NSLPP MEETING HELD ON 13/04/22

ADDRESS/WARD: 20 Berry Street, North Sydney

PROPOSAL No: 3/21

PROPOSAL: To amend North Sydney Local Environmental Plan 2013 at 20 Berry Street, North Sydney, as follows:

FIGURE 9: Overshadowing of Berry Street (West) Special Area on March equinox (21 March) as viewed from the northern elevation (Special Area shown in red)

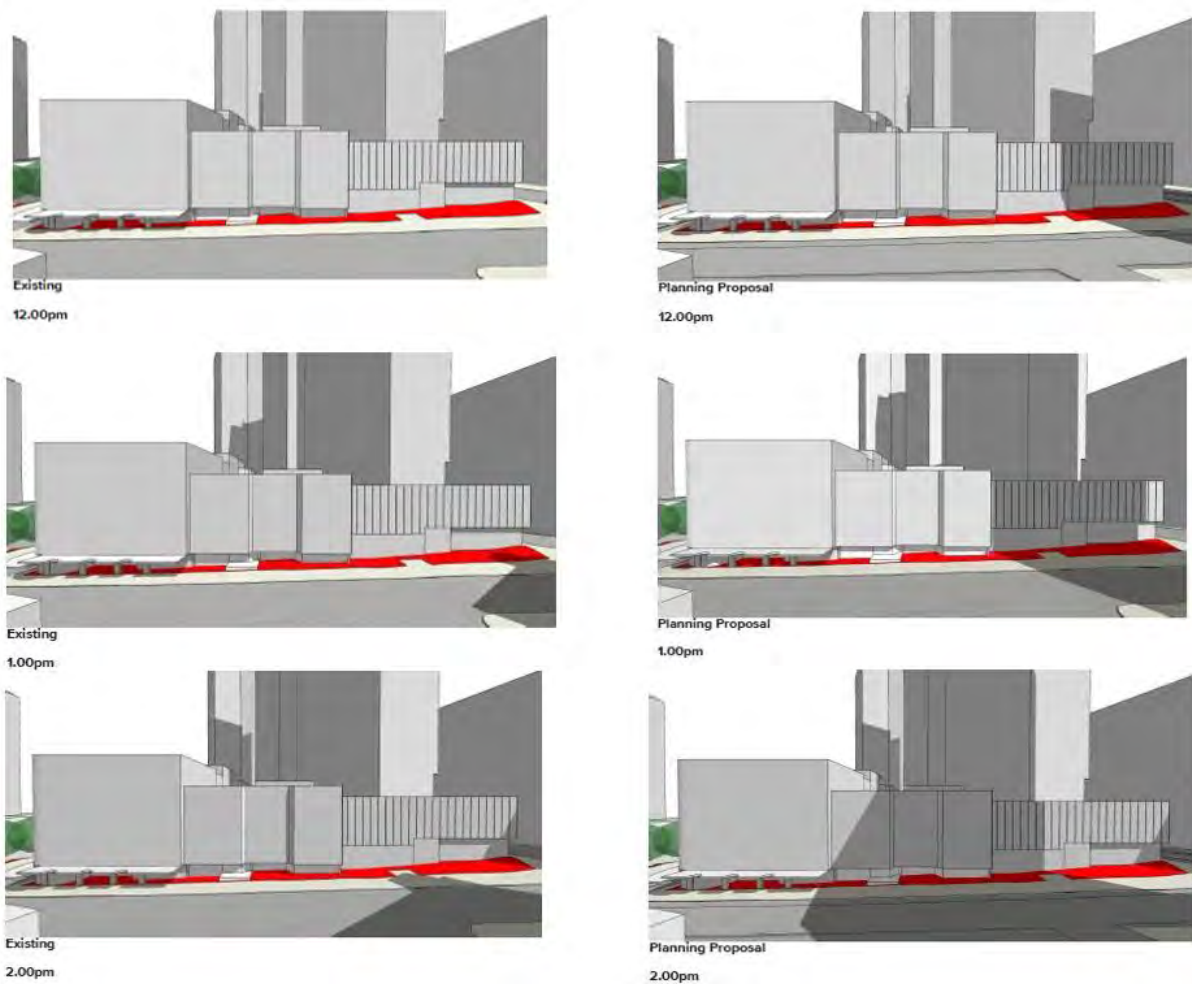
The proposal results in significant additional overshadowing during the 12.00 pm-2.00 pm period between the March and September equinoxes, with the majority of additional overshadowing occurring in March and in September. The 12.00 pm-2.00 pm period aligns with the lunch periods for many workers and providing sun-lit streets and spaces to walk, eat and gather at this time is a key goal of the PDS.

This is seen in figures 9 and 10 below, which show shadow diagrams from the March equinox (21 March):
